Report on Investigation into ventilation

Emerson House, Eccles

The Office of the Parliamentary Ombudsman

AS AT SEPTEMBER 2014.
COMMENTS ADDED BY MR JOHN DODLEY
TO POINT OUT WORST + MOST OBVIOUS "ERRORS".

Figure 1 Exterior view of Building

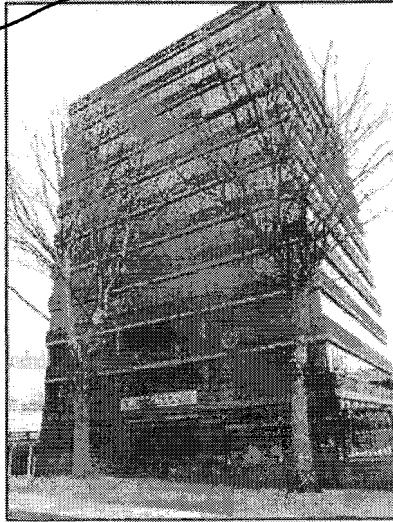
SO IS IT A DESIGNED NATURAL VENTILATION SCHEME — NO!

Figure 2 Ventilation airflow – still day and windy day

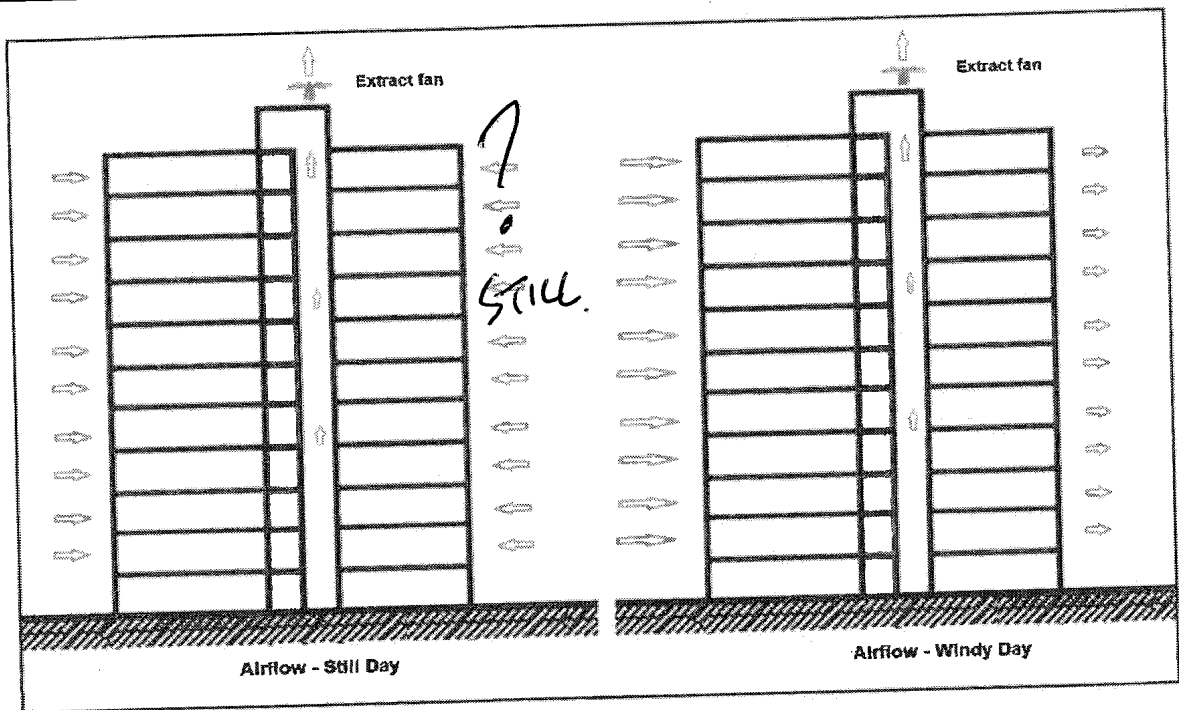
IS THE DIAGRAM TO BE
TAKEN SERIOUSLY — SEE PHOTOS...

THE MANY + VARIOUS CLAIMED
AIRFLOWS DEPENDING ON WIND OR
NO WIND SEEM MATTER OF
WISHFUL THINKING + BEAR NO
RESEMBLANCE TO ANY VALID
PHYSICAL PRINCIPLE OR
CIBSE ETC GUIDANCE - - - - -

Figure 3 View of office floor

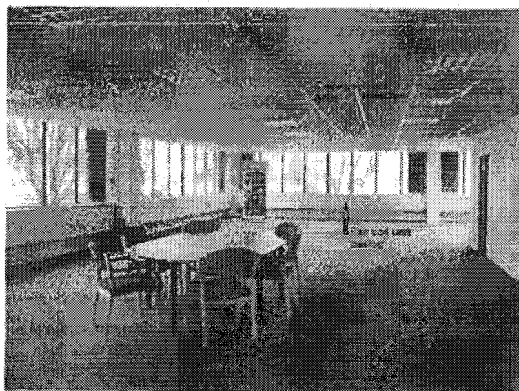
3.2 The heating and cooling is from fan coil units located in cases around the perimeter of the building. The air inlets are behind the fan coil unit casings. Figure 3 is a photograph of an empty office floor. It shows the perimeter casing and an extract air grille in the ceiling. These extract grilles are connected directly via ductwork to the roof extract fan. — BEING THE ORIGINAL RETURN AIR.

Figure 4 Diagram of Air change measurement (from HSL report ECM/2012/01)

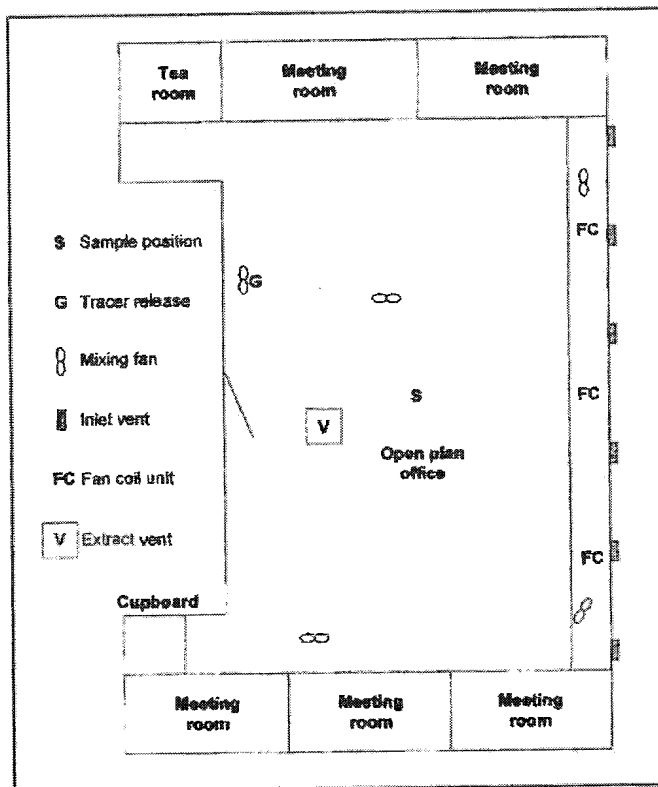
- WHAT INCOMPETENT NONSENSE!
MEETING ROOMS AGREED AS UNVENTILATED ANYWAY
